APPLICATION NO.	FILING DATE	FIRST NAMED INVENTOR	ATTORNEY DOCKET NO.	CONFIRMATION NO.
09/398,652	09/17/1999	WILLIAM A. SAMARAS	042390.P5120D	1359

Office Action Summary

DETAILED ACTION

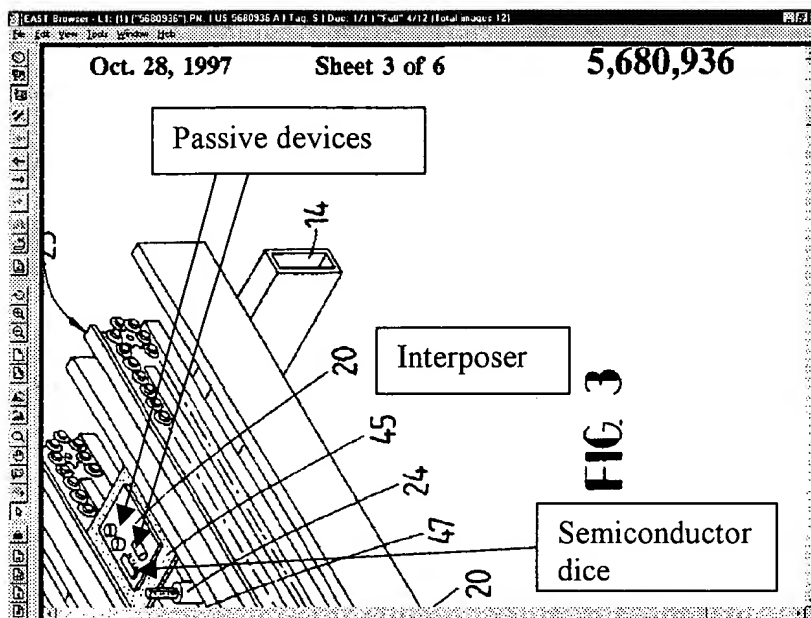
Beers discloses coupling at least one passive device (see annotated Fig. 3 below) thereby regulating voltage and current to the electronic dice.
